LAND USE APPLICATION SUMMARY

Property Location: 333 E Hennepin Ave
Project Name: US Bank
Prepared By: Kimberly Holien, Senior Planner, (612) 673-2402
Applicant: Cuningham Group
Project Contact: Jeff Schoeneck
Request: To construct a 3,290 square foot bank with a drive through.
Required Applications:

Site Plan Review	For the construction of a 3,290 square foot bank with a drive through
Minor Subdivision	To split the lot at 333 E Hennepin Avenue into two parcels

SITE PLAN

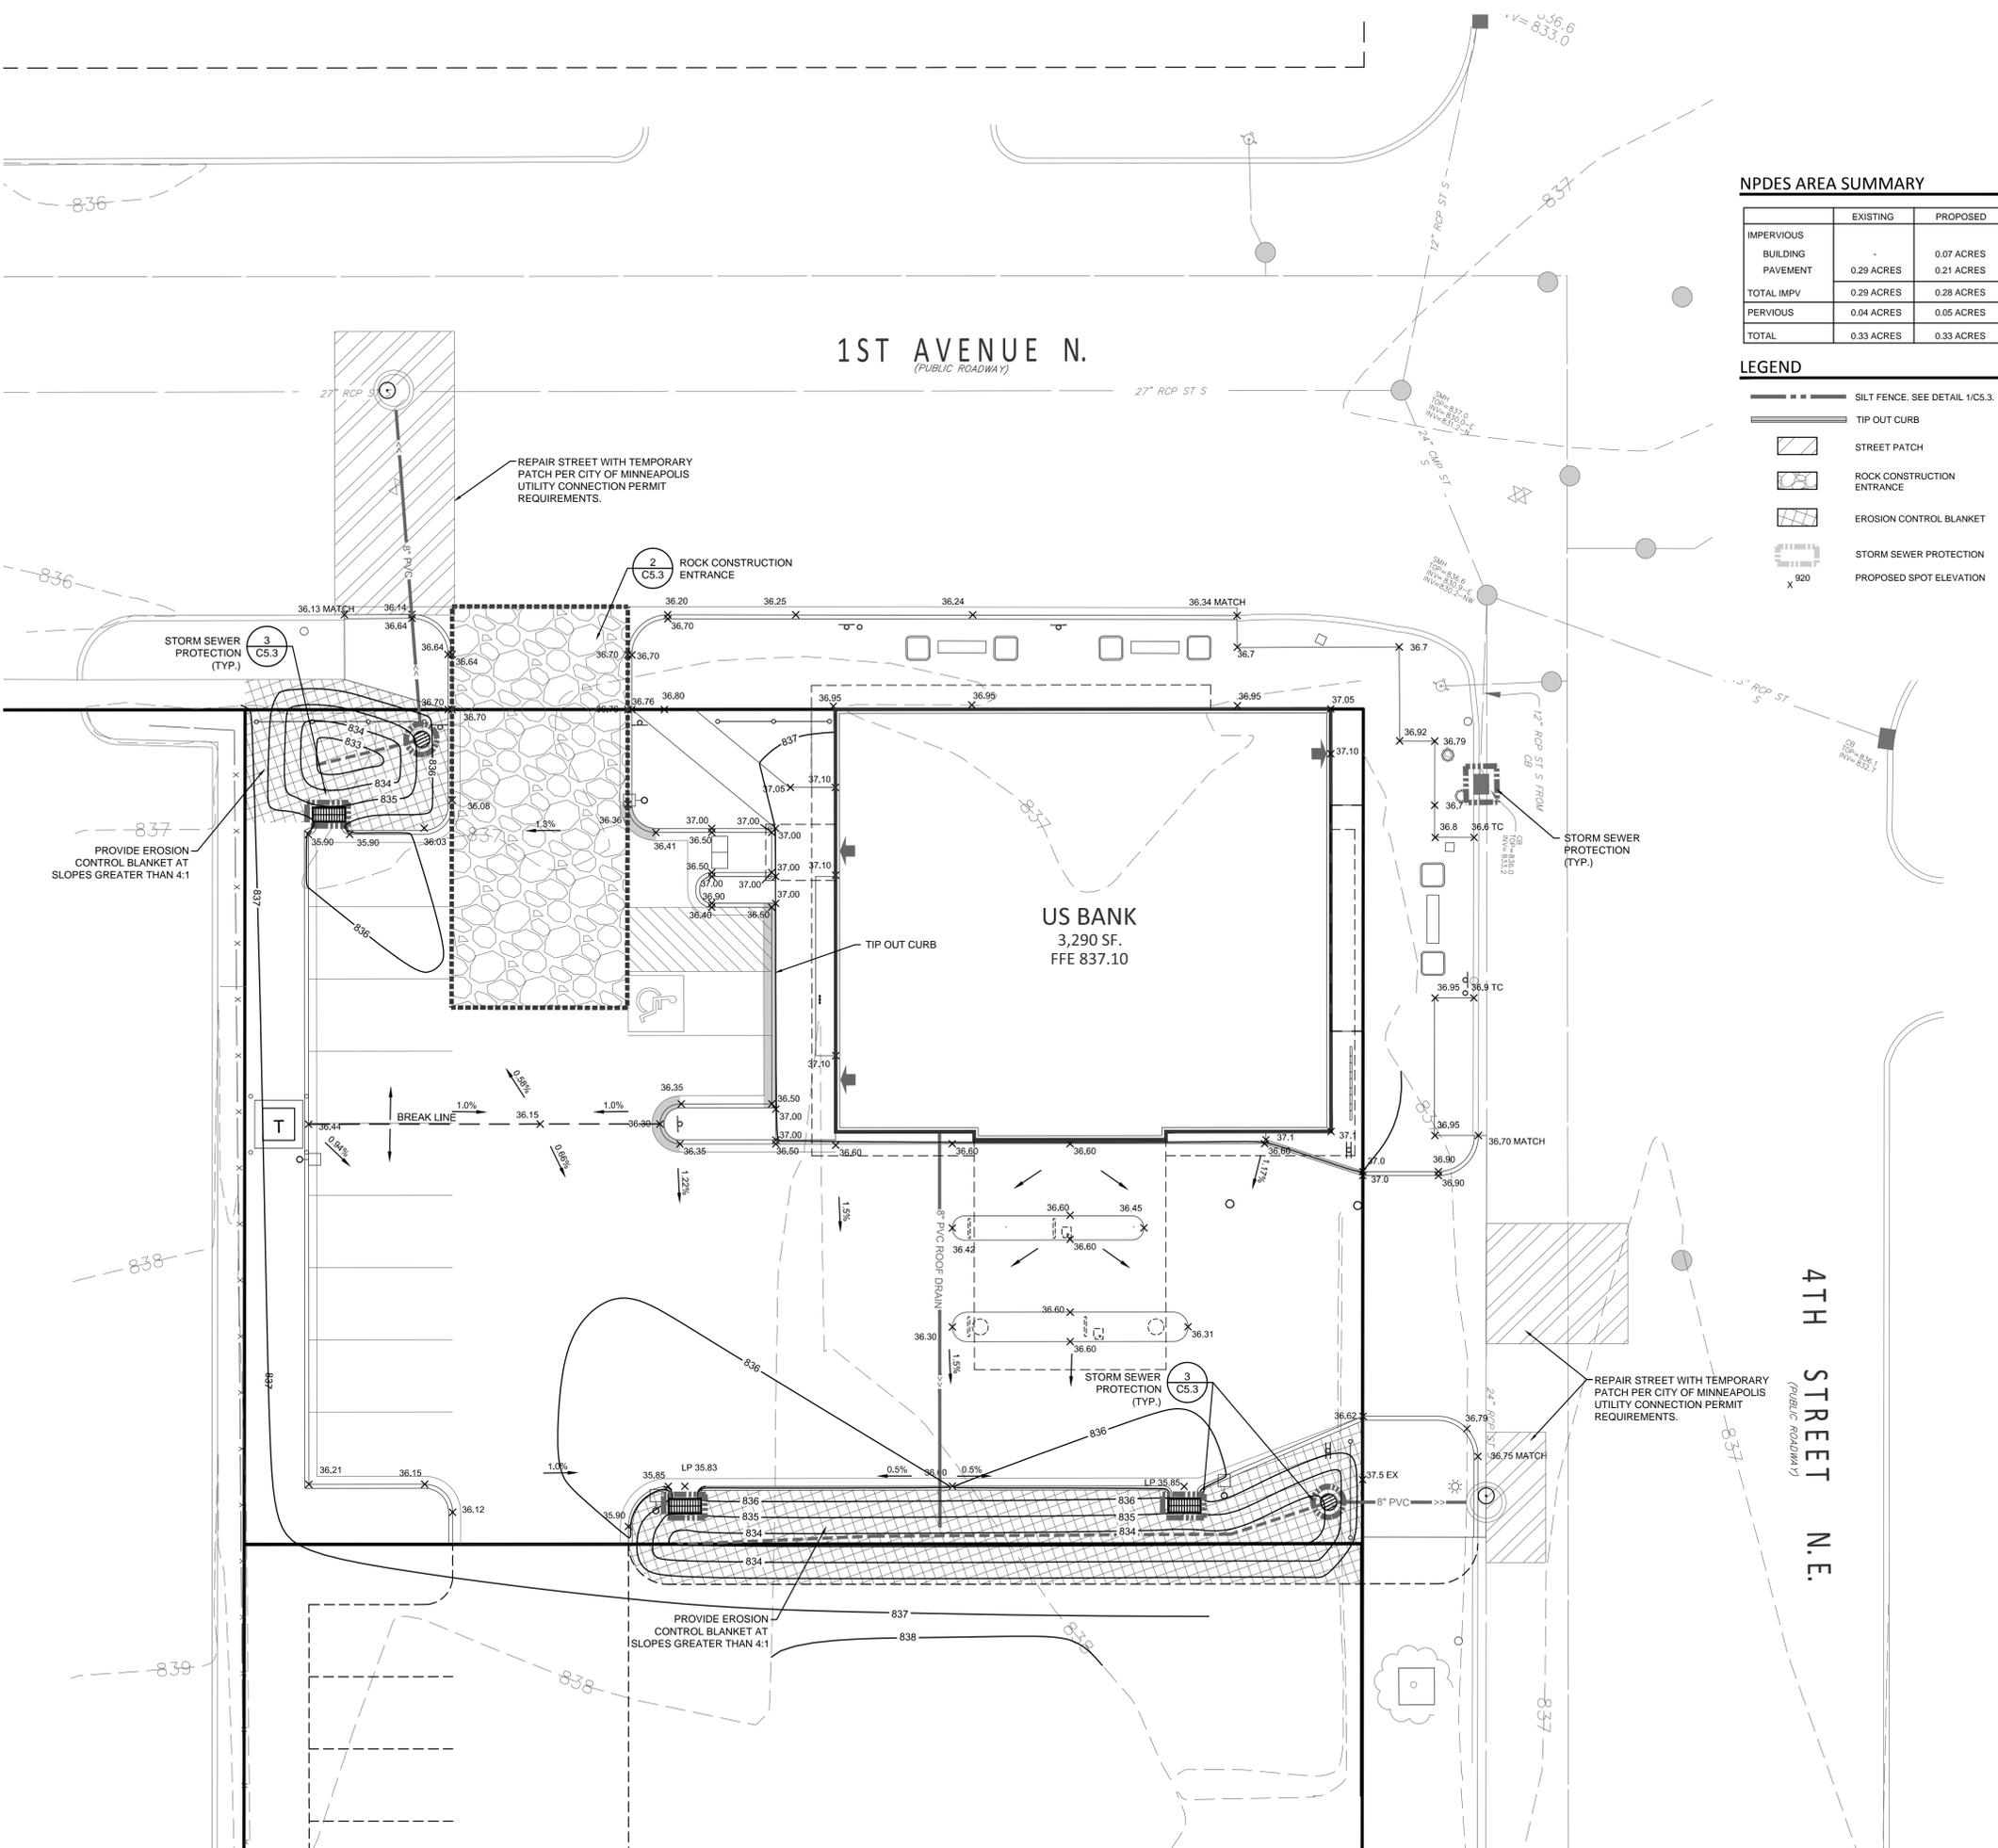
lane that exit onto 4th Street NE. The site plan has recently been updated by the applicant to show the curb cut in this location at 16 feet in width. However, other plan sheets in the packet show this curb cut as it was originally designed, at 30 feet in width. The zoning code limits curb cuts to 25 feet in width, except where a wider curb cut is determined necessary by the city engineer. In those cases, a curb cut shall still not exceed 35 feet. This curb cut was reviewed during the PDR process and the Traffic and Parking Division of Public Works recommended that the exit point onto 4th Street NE be limited to one vehicle at a time with a maximum apron width of 16 feet. The PDR report is attached. The revised curb cut shown by the applicant is consistent with staff recommendation. However, due to conflicting information on the plan sheets, a condition of approval will be added that limits this curb cut to 16 feet in width.

- The proposed 35' curb cut on 4th St. N.E. exceeds the typically allowable opening width of 25'. Larger openings are only allowed by variance; please provide a narrative and show turning movements in order to justify the larger dimension opening. Note that pavement markings indicating a "double left hand turn" onto 4th St. N.E. will not be allowed and shall be removed from the plans. It is recommended that the exit point onto 4th St. N.E. be limited to one vehicle at a time with a maximum apron width of 16', and the driveway apron on 1st Ave N.E. should have a maximum width of 20'

**GRADING & EROSION
CONTROL PLAN**

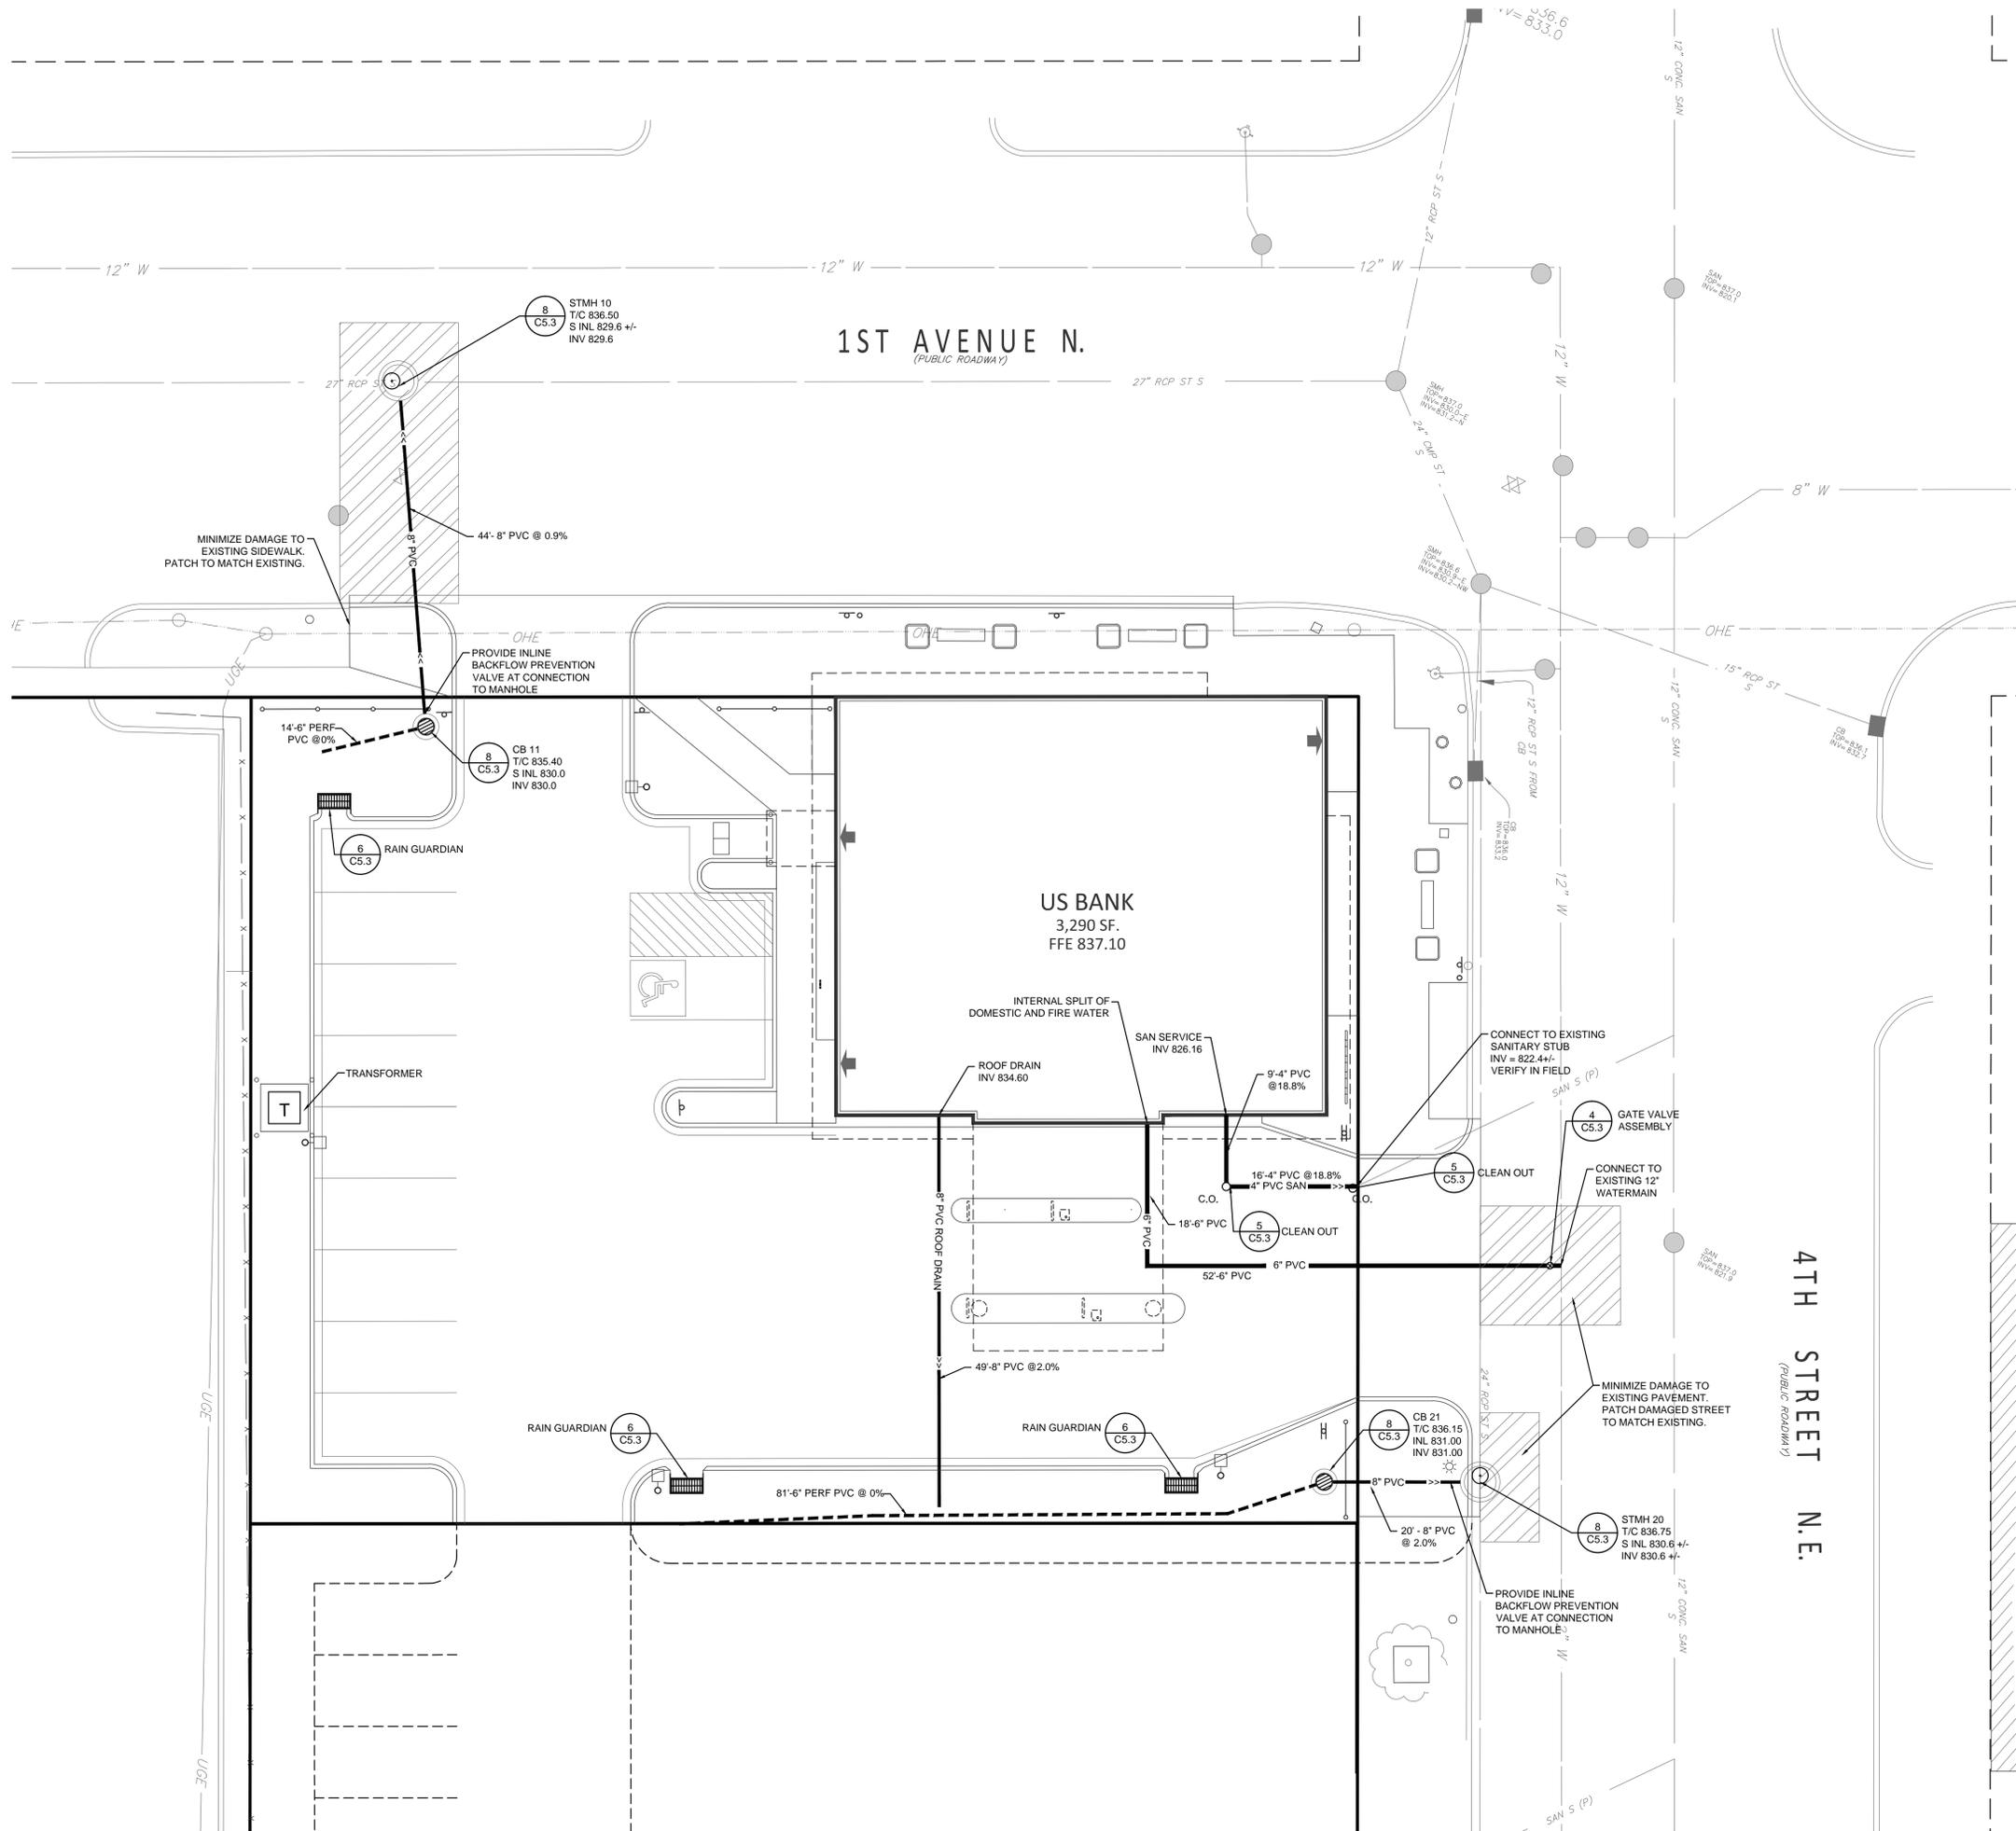
- The HydroCAD model indicates the filtration basins will be used as infiltration. Please adjust to model the proposed conditions. The overflow orifices are also modeled differently than what is shown on the detail on Sheet C5.3.
